SEARs request: Telopea Estate Redevelopment – Concept development application (staged development) and Stage 1A development application

ATTACHMENT 1**Draft SEARs - Section****Recommended Additions / Edit to Requirements****Part 1 – Statutory and strategic context**

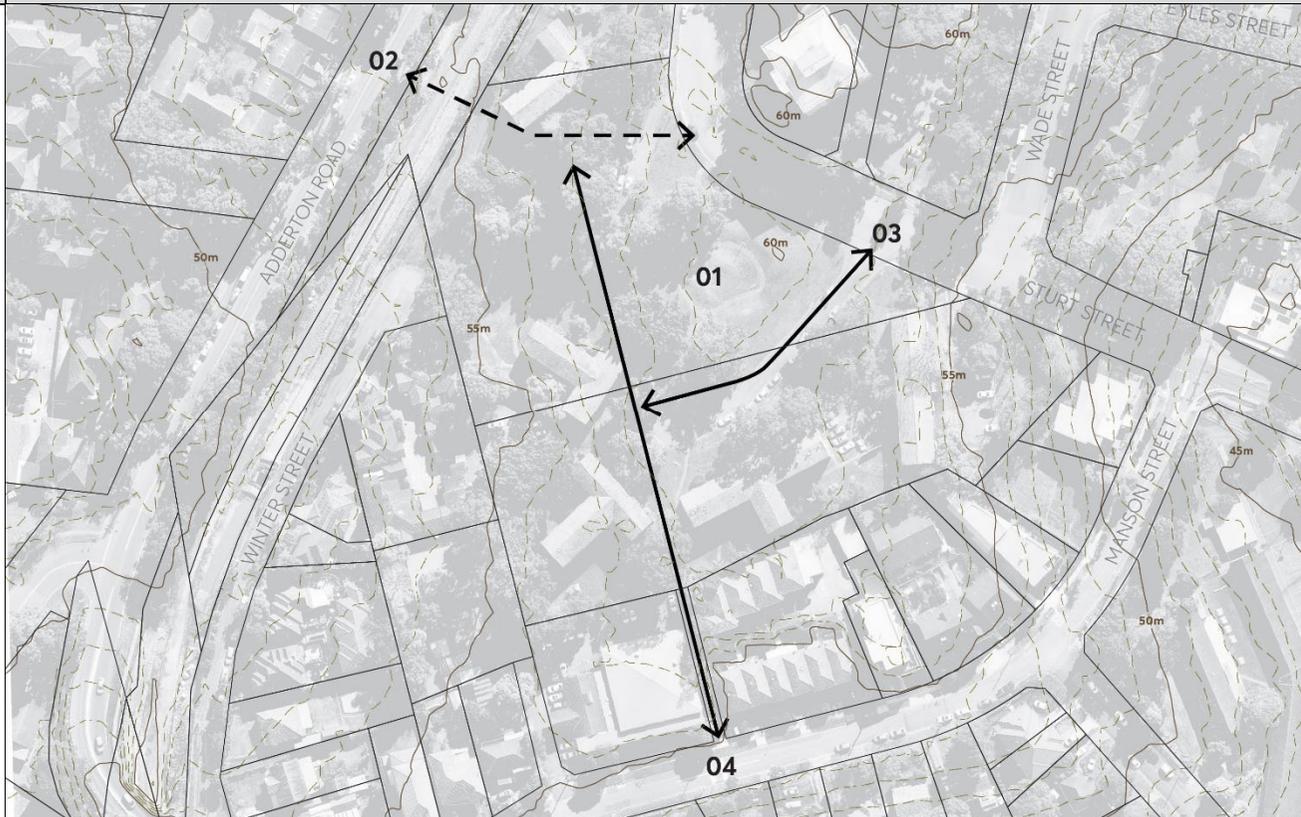
ATTACHMENT 1	
Draft SEARs - Section	Recommended Additions / Edit to Requirements
	<ul style="list-style-type: none"> - Preserve sightlines across the precinct by providing views to sky or terminating in open space. - Be provided as publicly accessible through site links between large street blocks, including new pedestrian and cycle links to the Greenway Corridor. - Have consistent kerb lines and boundary to boundary distances when connecting to the surrounding network so that there is no narrowing of the 'space' of the street between the surrounding area and the core. - Provide all buildings with a legible street address. <p>New streets and/or publically accessible through site links are to be provided as part of the Stage 1A proposal (Polding Place). The proposed form does not adequately provide a legible street address to both buildings on site. At least one publically accessible street (recommended in the approximate location of the existing Polding Place alignment where topography is relatively uncomplicated) is to be provided and represented as part of the future subdivision plan. See below preferred structure of Polding Place:</p>

- 01) Preferred location for future public open space at highest point on site and Sturt St access
- 02) Approximate location of future street as per Telopea Masterplan 2017
- 03) Preferred location for future publically accessible street (minimum 16m wide)
- 04) Preferred location for future through site link (pedestrian or combination of pedestrian and vehicular access)
